01/29/2025
CAL FTL 13-003

Subject: 114SD's Ordered with 2-Cylinder Air Compressors Delivered Without Pressure Relief Valve

Model: Business Class M2 and 114SD

Fig. 1 Safety Valve, Fitting and Discharge Port

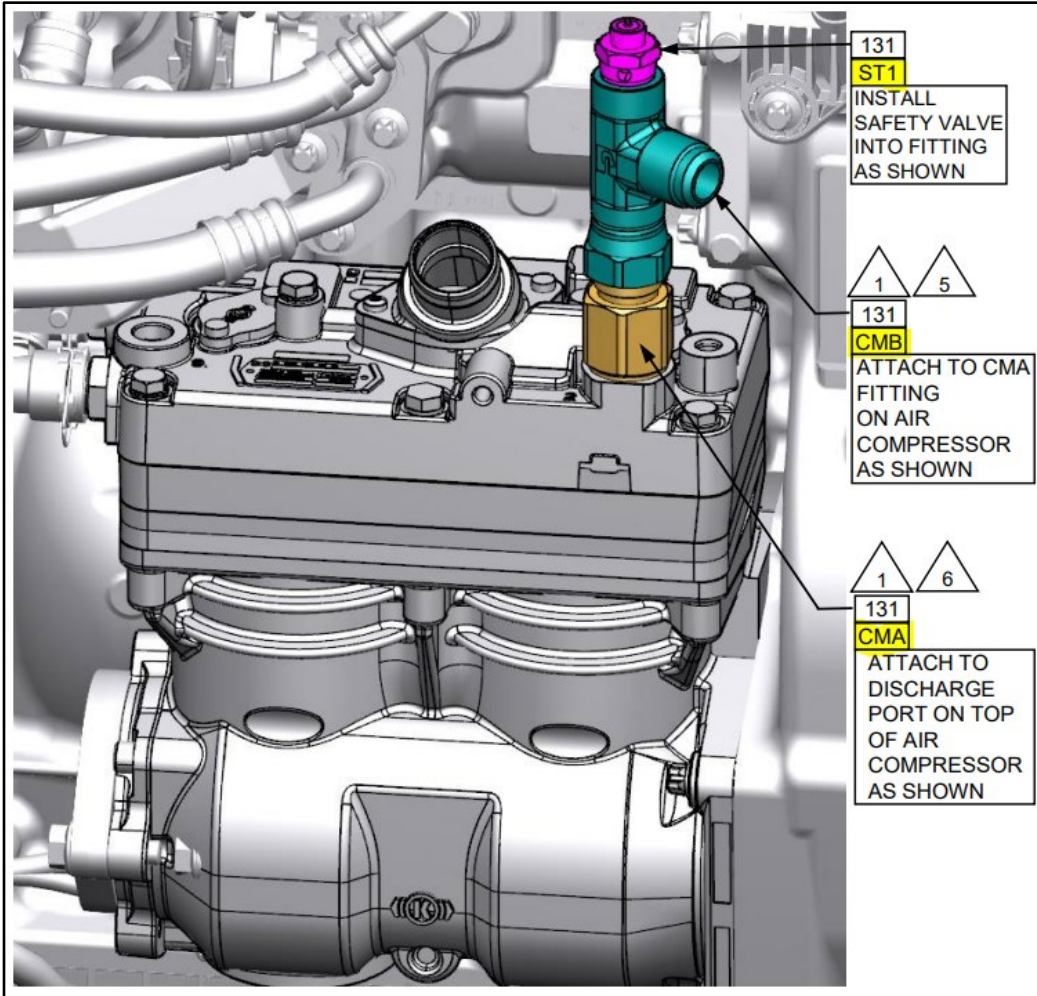
1. Park the vehicle on a level surface, shut down the engine, and set the parking brake. Chock the tires.
2. [Figure 1](#), module 131, shows the 2-cylinder air compressor (grey color) with the correct pressure relief valve (Ref ST1), Tee (Ref CMB), and adapter (Ref CMA).

Fig. 2 Adapter

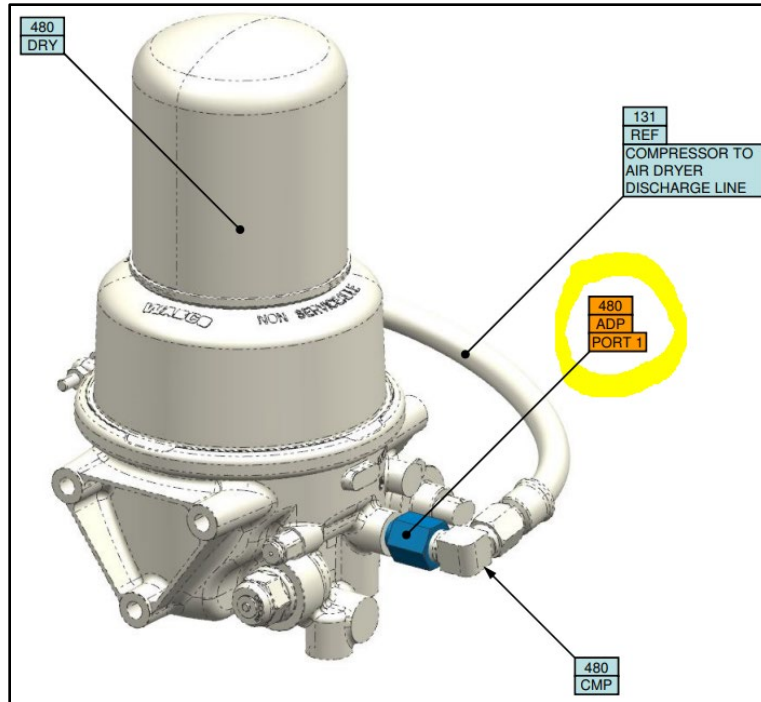
3. See [figure 2](#) for adapter (Ref ADP), module 480.

- See [Table 1](#) for the list of serial numbers that require updating with the correct 2-cylinder air compressor discharge BOM, the new module 480 fitting, and the responsible DSM.
